## Advice to decision maker on coal mining project

### Proposed action: Byerwen Coal Project (EPBC 2010/577, MF205) – New Development

<b>Requesting agency</b>	Department of Sustainability, Environment, Water, Population and Communities and Office of the Coordinator-General, Queensland Department of State Development, Infrastructure and Planning
<b>Date of request</b>	24 July 2013
<b>Date request accepted</b>	24 July 2013
<b>Advice stage</b>	Environment Impact Assessment (draft)
<b>Summary of request from the regulators</b>	<p>The Department of Sustainability, Environment, Water, Population and Communities (the Department) is currently assessing the proposed project in accordance with the provisions of the <i>Environment Protection and Biodiversity Conservation Act 1999</i> (EPBC Act) and the Office of the Coordinator-General (the Office), Queensland Department of State Development, Infrastructure and Planning, is currently assessing the proposed project under Part 4 of the <i>State Development and Public Works Organisation Act 1971</i> (SDPWO Act).</p> <p>The Department and the Office, in accordance with the bilateral agreement triggered on 4 March 2011, advise the Committee of a

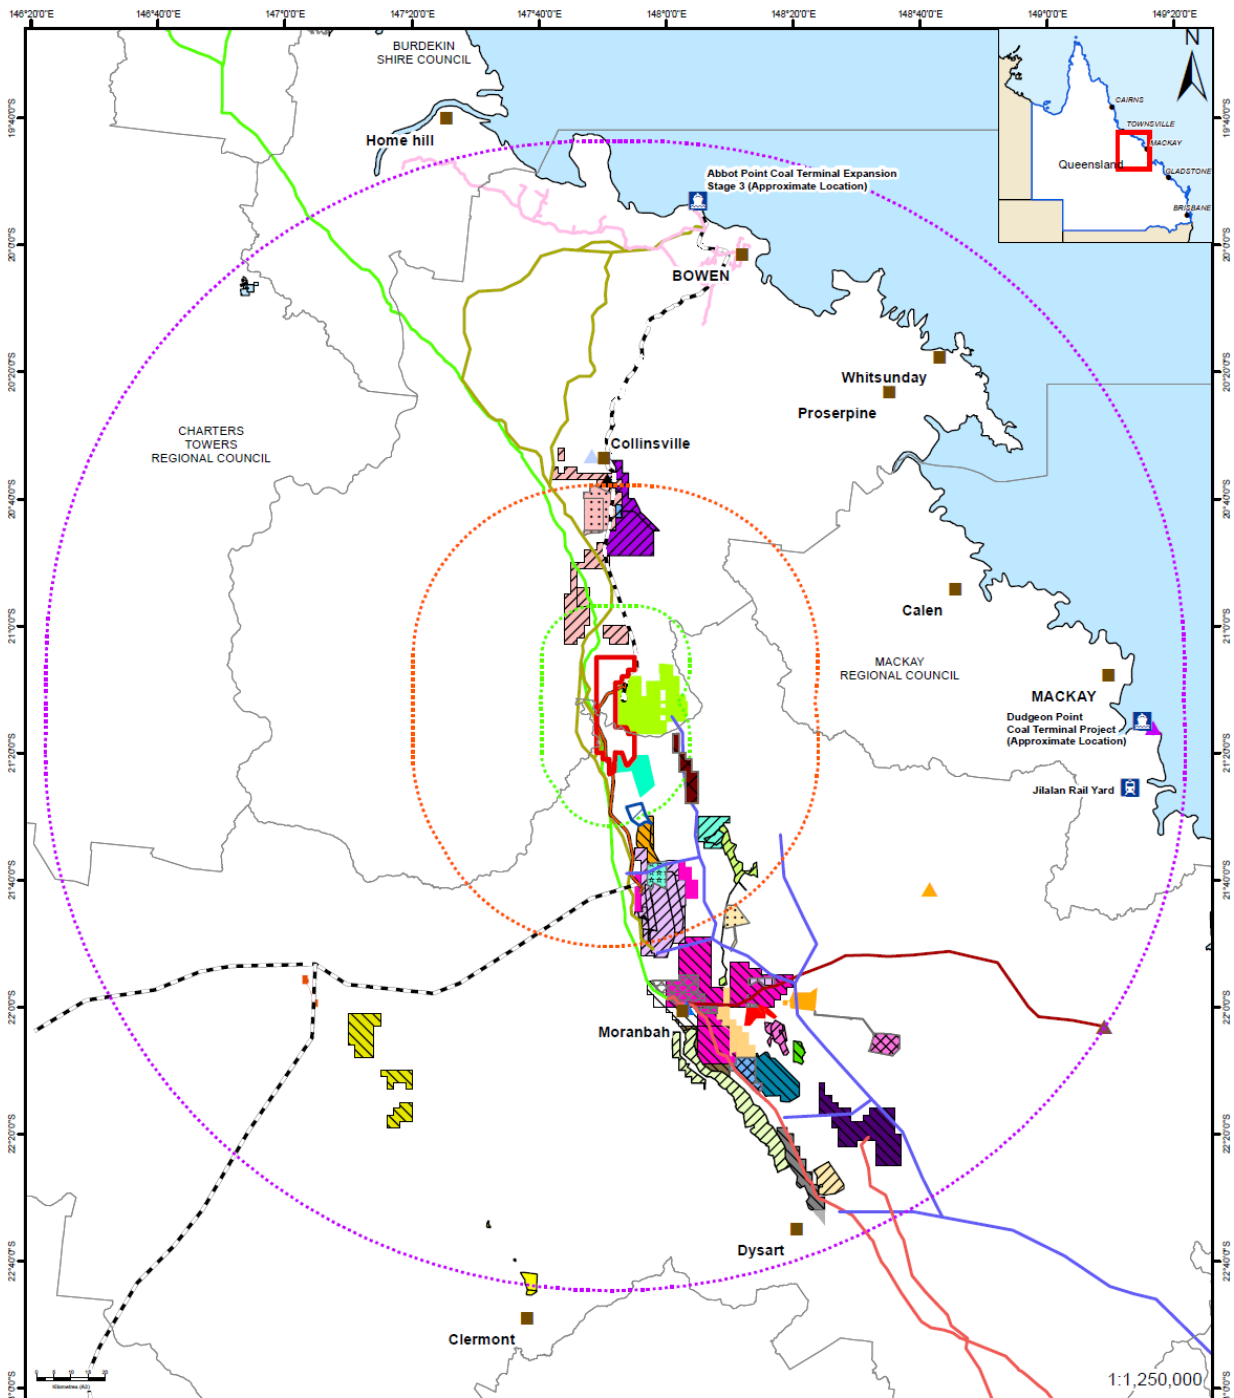
12. The Committee notes that there are large numbers of existing or proposed coal mining and coal seam gas operations in the northern Bowen Basin (see Attachment A to this advice from the proponent's assessment documentation), including some operations on which the Committee has previously provided advice. The Committee considers that these operations in the region present a significant risk of cumulative impacts, in particular:

- a. Cumulative groundwater drawdowns;
    - b. Disturbance of natural catchments and regular discharge of mine water to surface water catchments which ultimately flow to the Great Barrier Reef;

- d. A legacy of multiple final voids with the potential for highly saline discharge to regional surface and groundwater systems post production.
13. In relation to cumulative impacts, the regional extraction of large quantities of coal and overburden will create a regional scale linear void and result in de-stressing and redistribution of crustal loading along the eastern edge of the Bowen Basin. Consequent seismicity and spatial changes in the relationships of stratigraphic units and/or topography have the potential to change aquifer interconnectivity and surface water flows. The consequence of establishing a deep linear void trending parallel to many subsurface structural lineaments, including faults, would benefit from further scientific investigation.

14. The Committee considers that the scale and rate of development of coal seam gas and coal mining operations will significantly alter the existing hydrological and hydrogeological processes in the northern Bowen Basin. Therefore, the Committee recommends that regulators establish a collaborative approach across involved industries in the northern Bowen Basin to predict, monitor and manage the potential cumulative impacts to surface and groundwater resources.
